Comment Resolution Form
North IPT – Environmental Restoration

Document: Abbreviated Work plan June2018 Vertical Profile Boring (VPB177) / Recovery Well (RW4) Installation for RE108 Hot Spot, NWIRP Bethpage			Version / Final		Document Receipt Date: 12 June 2018		
Review Comments By: Brian Murray, RPM			Phone: 757-641-0491		Note: Discussion provided by Resolution Consultants, March 6, 2018

**ABBREVIATED WORK PLAN – OCTOBER 2018
RECOVERY WELL (RW4) INSTALLATION FOR RE108 HOT SPOT
NAVAL WEAPONS INDUSTRIAL RESERVE PLANT (NWIRP), BETHPAGE, NEW YORK**

CONTRACT NUMBER N62470-11-D8013	CTO NUMBER WE15
APPROVED BY PS	DATE 9/25/2018
APPROVED BY —	DATE —
FIGURE NO. 1	REV 0

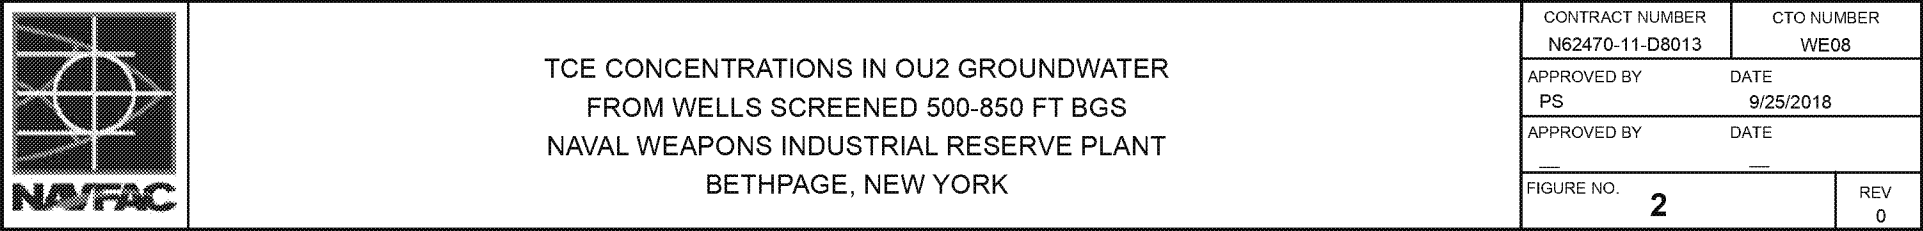
Comment Number	Page #	Line, Section, Figure or Table	Comment	ur Conc	ur Conc	Non- Conc	Discussion
1	1	Paragraph 2	Scope and Objectives, Second Paragraph, the last sentence states: "During the drilling of the recovery well, the lithology will be logged to assess the future locations and construction of the RE108 hot spot recovery well(s)." What is intended by this sentence? Is this sentence referring to an additional Phase 1 recovery well or to the Phase 2 recovery wells?	X			This sentence has been deleted.
2		Bullet 2	Scope and Objectives, 2nd bullet. The second sentence should be revised by inserting "a" between "and" and "groundwater".	X			Text revised as stated.
3		Figure 3	The report text references Figure 3, but no Figure 3 is included in the Work Plan.	X			Reference to Figure 3 removed.
4		Figure 1.	The report text indicates that Figure 1 illustrates the site location relative to Long Island, but Figure 1 is a local map showing the RE108 and RW4 area.	X			Reference to regional has been removed.
